County of Santa Barbara Planning and Development

PLANNING COMMISSION
HEARING OF OCTOBER 26, 2009

RE: Santa Barbara Botanic Garden Vital Mission Plan; 99-DP-043, 72-CP-116 RV01

RE: Revisions to 07EIR-00000-00001, the proposed Final EIR for the Santa Barbara Botanic Garden Vital Mission Plan (72-CP-116 RV01, 99-DP-043) to reflect revisions proposed subsequent to completion of the proposed Final EIR for the project and prior to decision-maker action (including potential certification of the FEIR)

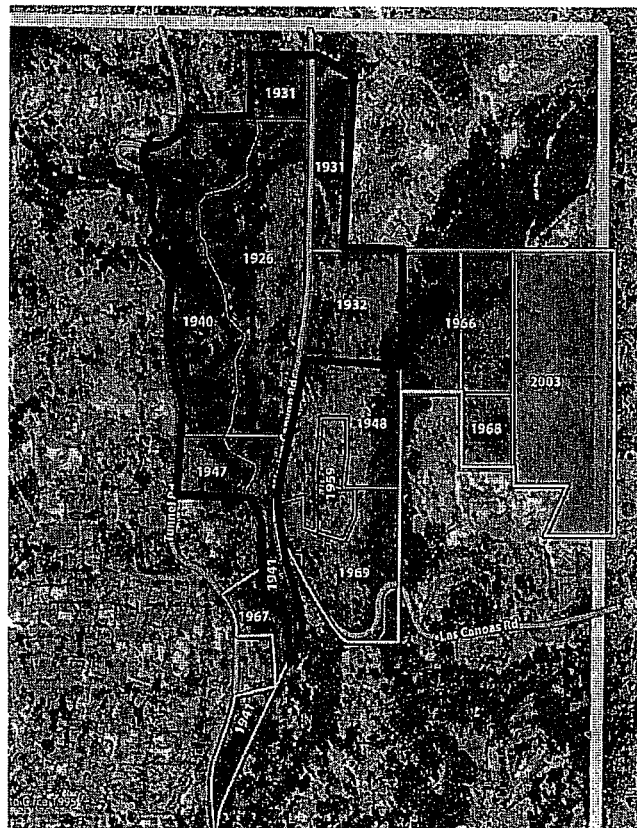
A discrepancy in the boundaries of the Historic Garden and associated parcel numbers was identified. The discrepancy arose as a result of inaccurate parcel boundaries and configurations on a site map that was utilized by Historic Resources Group (HRG) in identifying the boundaries of the Historic Garden. The text description of the boundaries in the report, and which parcels are excluded from the boundaries due to a lack of association with the Garden's operation during the period of significance, does reflect the correct boundaries and requires no changes. Page 4.4-10 of the EIR, reflecting the HRG report, currently states:

However, Figure A (below) in the report does not reflect this text description due to the error in the parcel boundaries and configurations in the underlying base map.

A corrected base map (see below) has been provided and the boundary of the Historic Garden adjusted accordingly. The correct acreage for the updated boundary is 36.47 and includes seven separate parcels:

- APN 023-340-015 (1926)¹
- APN 023-350-006 (1931)
- APN 023-052-001 (1932)
- APN 023-340-013 (1940)
- APN 023-340-014 (1940)
- APN 023-060-023 (1941)
- APN 023-060-022 (1947)

The result of this correction is that the new buildings proposed as part of the Horticultural Offices (P-6/7/8 and P-9) on the east side of Mission Canyon Road in the area of the existing shade structures would be adjacent to but outside of the boundaries of the Historic Garden as identified by HRG. The HRG report, as restated in the EIR, concluded that impacts to the Historic Garden from development of these structures would be less than significant (Class III). The corrected boundary would not alter this conclusion. In addition, the boundary correction does not alter the extent of trails that are included within the Historic Garden, since the Porter Trail remains within the parcel north of the Horticultural Offices. Thus overall, the boundary
